Michigan Department of Environment, Great Lakes, and Energy

Wolverine CAG – Revised Draft Tannery Interceptor System Response Activity Plan

June 28, 2023

Figure 1. The Influence of Diffusion, River Stage, and Water Elevation on Piezometer Values.

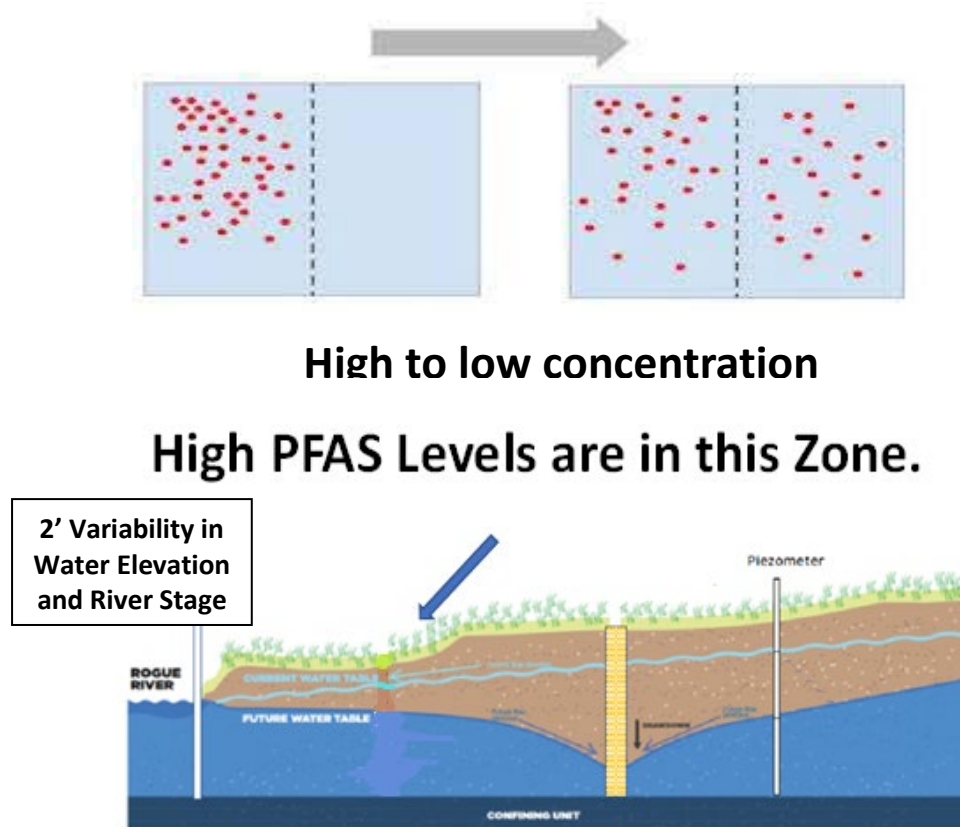
We provided a detailed description of why PFAS would migrate from the highly contaminated soils near the river to surface water by diffusion in our 1/27/23 response letter. PFAS transport will still occur by diffusion from high to low concentration gradients (site to the surface water) and from low permeability soils to the permeable gravels and sands in the stream (Fetter et al. 2017). Flowing water (especially during high flow events) and burrowing organisms will also enhance contaminant diffusion. Due to site heterogeneity impacting the representativeness of the piezometers and issues with the conclusions about pore water and the inherent uncertainty associated with water elevation measurements (Figure 1), the only way to

reduce PFAS transport by diffusion is to maintain a negative gradient where the groundwater is not stagnant and is moving away from the river to the trench. We strongly feel that conditions where no gradient is present are unacceptable. We request that EGLE require WW to maintain a negative gradient that will prevent PFAS diffusion from high concentrations in the riverbank soils to the Rogue River and Rum Creek. We also found no reference in the revised plan to the extent of the water table drawdown that the trench system will achieve. The system should be designed to achieve a targeted drawdown level to meet the requirements of the Consent Decree.

Figure 2. Variability of Piezometer Water Elevations (GZA) and Rogue River Stage (USGS 2021 and 2022).

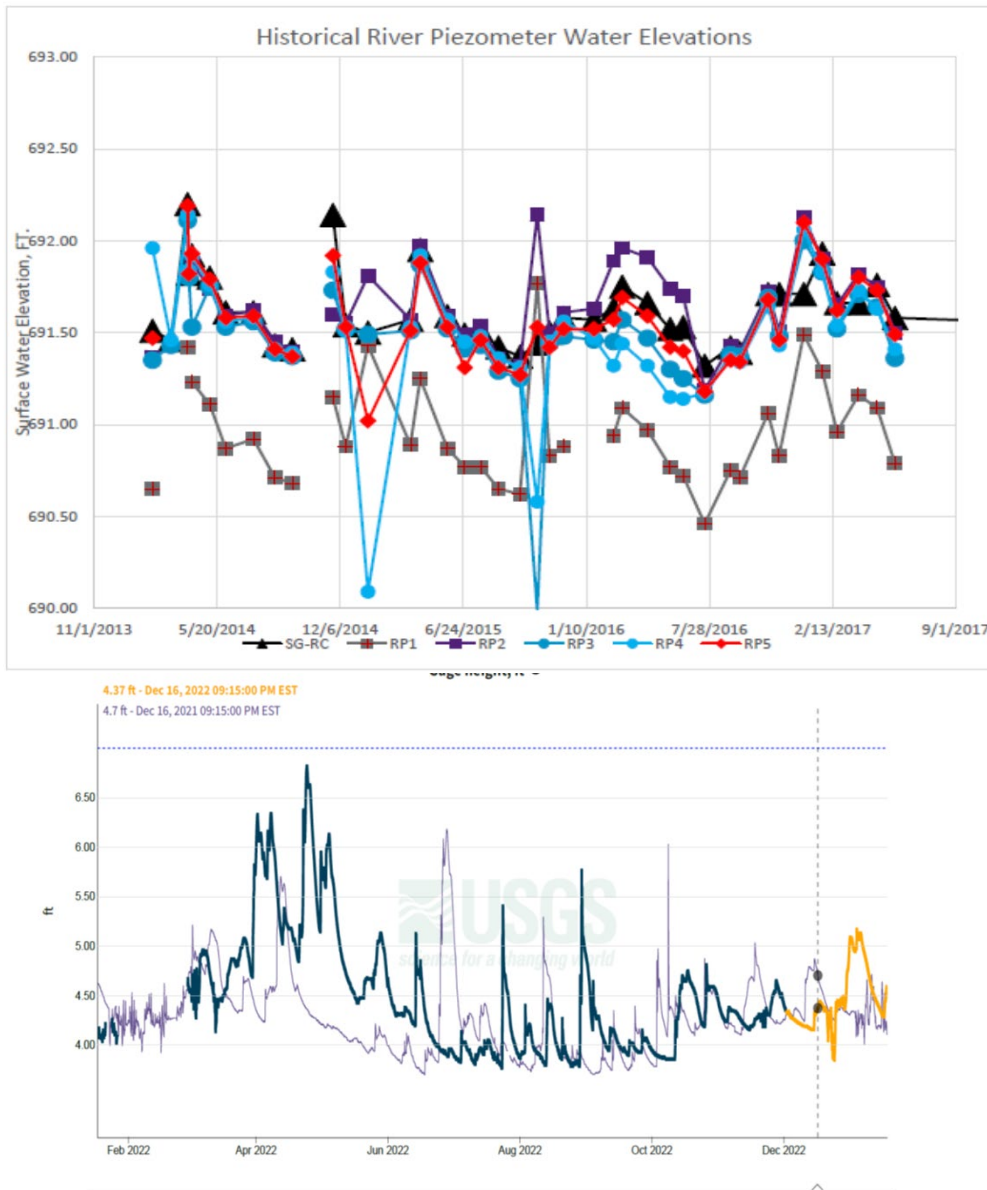
We provided information in our 1/22/23 letter that historical groundwater levels and river stages can vary over 2 ft (Figure 2). The proposed weekly monitoring schedule does not reflect the

the hydrologic complexity of the system by the time the piezometer is downloaded and processed, more than a week of noncompliance with maintaining a negative gradient may occur.

Other than cost cutting, there is no reason to monitor the compliance part of the groundwater interceptor system at a lesser frequency than the levels in the sumps. We made this request in our 1/27/23 response letter, and we again are requesting that the monitoring of piezometer arrays used for water elevation measurements be automated by pressure transducers that can continuously record and transmit water level data.
